Work Order ID 96420

Item Name: Crosstube Aft

DART AEROSPACE LTD		Work Order:	96420
Description: Crosstube High Aft (412)		Part Number:	D412-664-203
Inspection Dwg: D412-664-243 Rev: E		Page 1 of 1

DRAWING NO. D412-664-243	TITLE CROSSTUBE ASSEMBLY (412 HI AFT)	REV. E	DART AEROSPACE LTD ENGINEERING ORDER		D.E.O. NO. D412-664-243-E-1	SHEET NO. SHEET 1 OF 2	SCALE NTS
DRAWN	CHECKED <i>MP</i>	MFG. APPR. <i>E</i>	APPROVED <i>MP</i>	DE APPR. <i>MP</i>			
DATE 11.03.31	DATE 11/03/31	DATE 11.03.31	DATE 11/03/31	DATE 11.03.31

**D412-664-243
ASSEMBLY DETAIL**

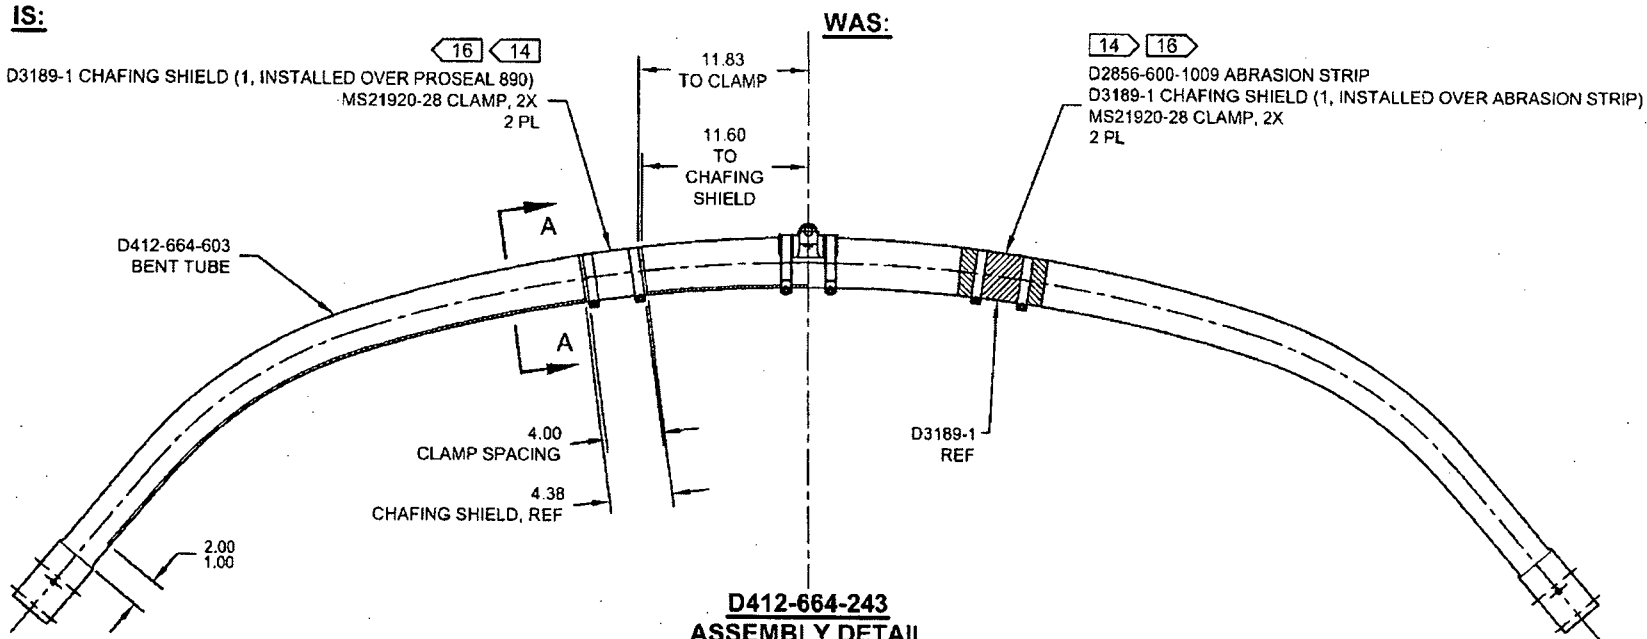
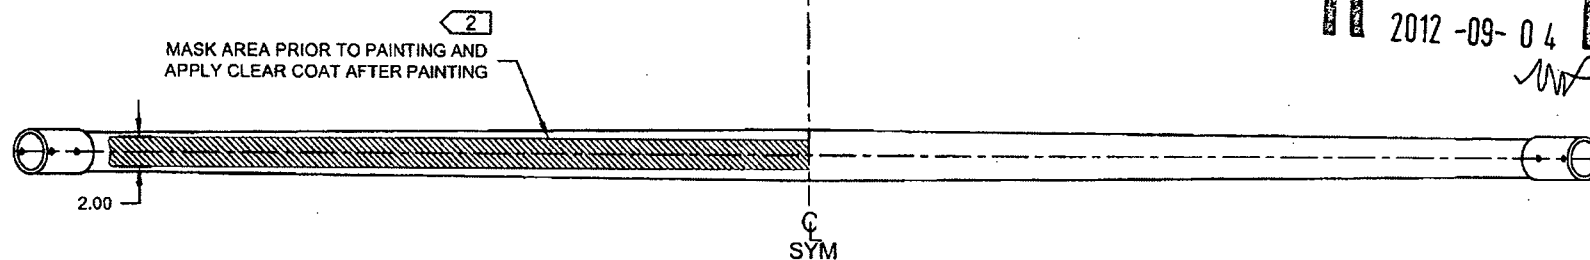
D3189-1 CHAFING SHIELD (1, INSTALLED OVER PROSEAL 890)
MS21920-28 CLAMP, 2X
2 PL

D2856-600-1009 ABRASION STRIP
D3189-1 CHAFING SHIELD (1, INSTALLED OVER ABRASION STRIP)
MS21920-28 CLAMP, 2X
2 PL
